Addendum 136 – Regulation No. 137

Amendment 1

01 series of amendments to the Regulation - Date of entry into force: 17 December 2016

Uniform provisions concerning the approval of passenger cars in the event of a frontal collision with focus on the restraint system

Model A

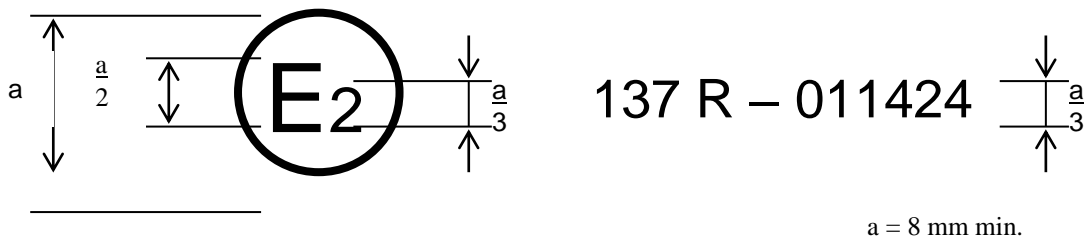
Annex 2, amend to read:

The above approval mark affixed to a vehicle shows that the vehicle type concerned has, with regard to the protection of the occupants in the event of a frontal collision, been approved in France (E 2) pursuant to Regulation No. 137 under approval number 011424. The approval number indicates that the approval was granted in accordance with the requirements of Regulation No. 137 01 series of amendments.
